**REMARKS**

Favorable reconsideration of this application is requested in view of the foregoing amendments and the following remarks. Claims 30-61 are pending in this application. Claims 1-12 and 27-28 are canceled without prejudice or disclaimer. Claims 13-26 and 29 were previously canceled without prejudice or disclaimer. Claims 30-61 are newly presented.

ATTORNEY'S DOCKET  
UBAT1440-1

10/722,274  
Customer ID: 38396

Fig. 5

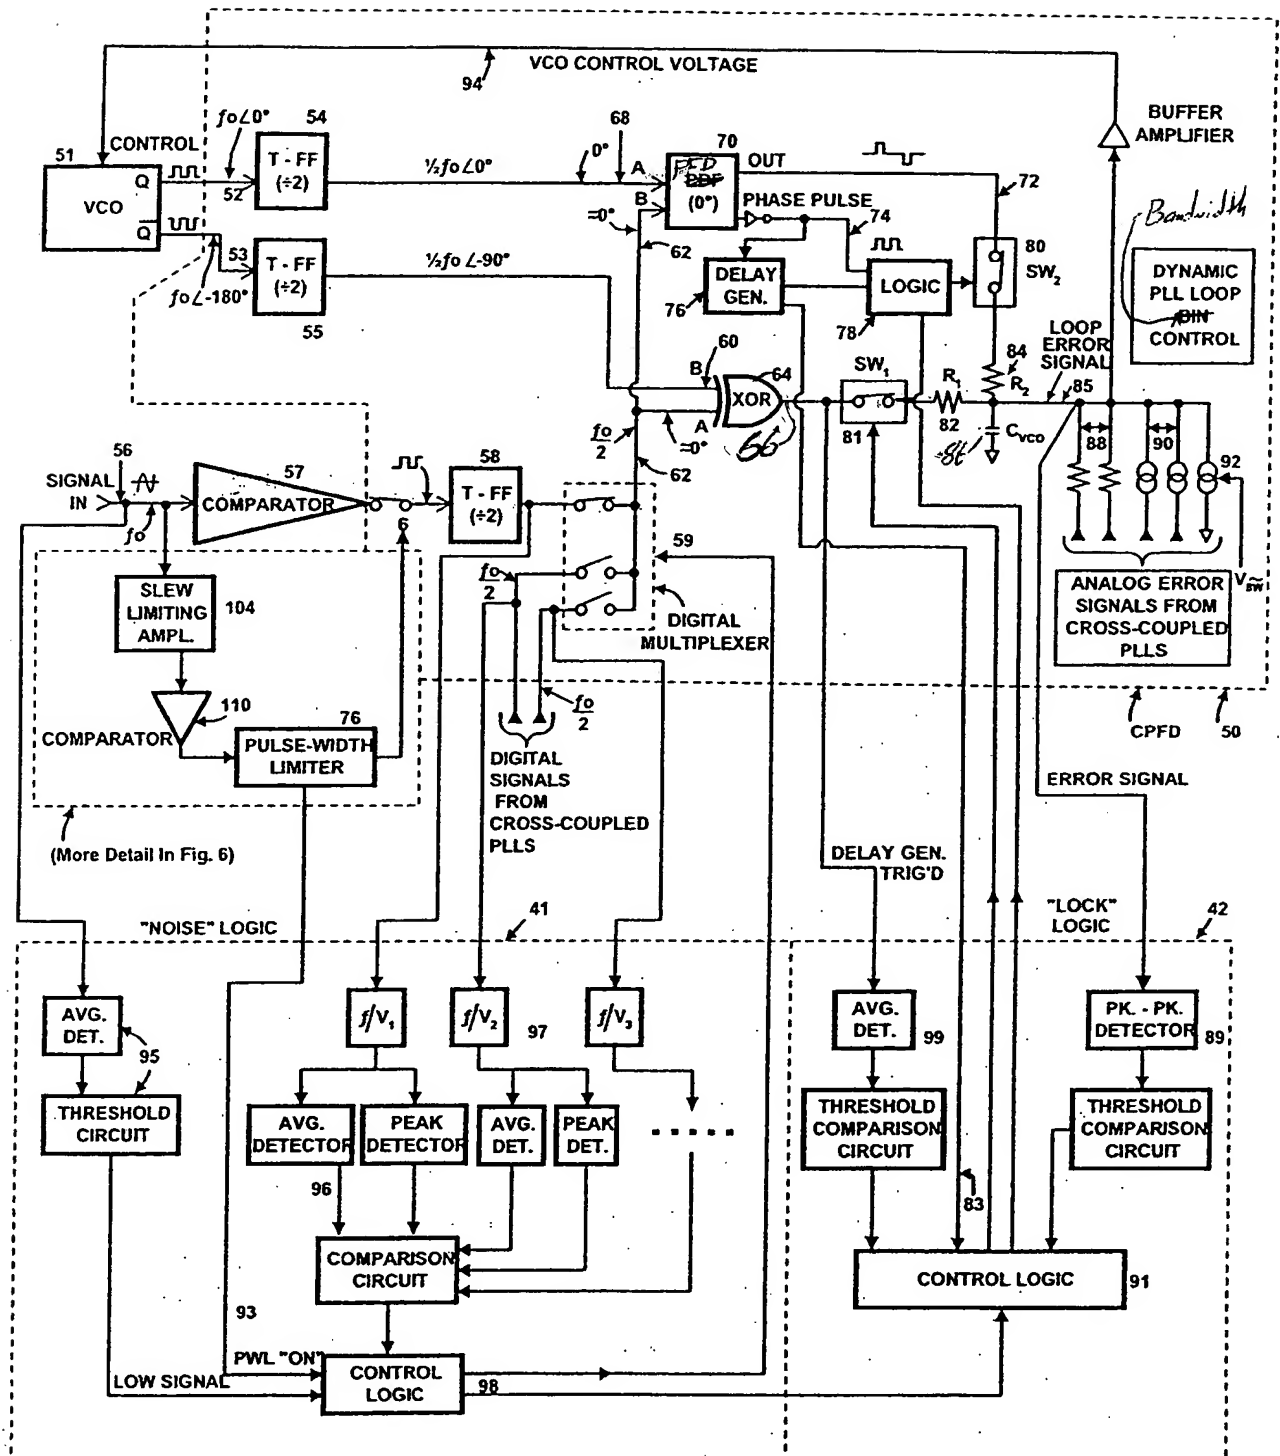
markings. Support for the depiction of detail number 66 in figure 5 is found at line 15 of page 21 of this application as originally filed. Support for the depiction of detail number 86 in figure 5 is found at line 10 of page 22 of this application as originally filed.
